DOCUMENT CHANGE REQUEST

DCR number 558

Title: Accessories for Connectors Microminiature 3401/029, 3401/077 and Connector Savers 3401/041

Number: 3401/032

Variant 10 - Screwlock Assembly for Connector Savers

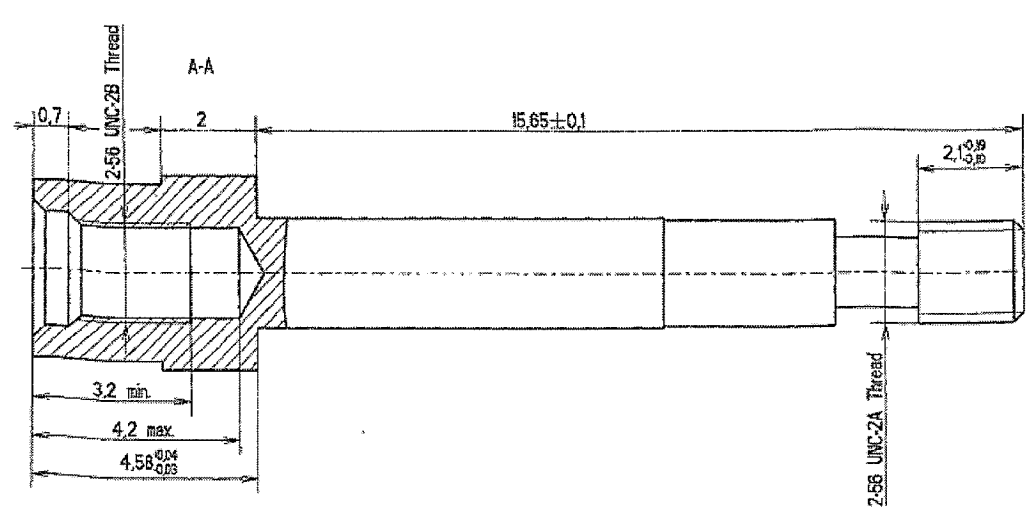
Page 10 : representation of the screwlock to be modified as shown in the attached document.

No word changing, only diameter of the screwlock added on the picture and 2 diameters very similar replaced by a single one.

Current representation with 2 diameters very similar and no value specified is replaced by a single diameter of 2.13 mini.

FUTURE REPRESENTATION
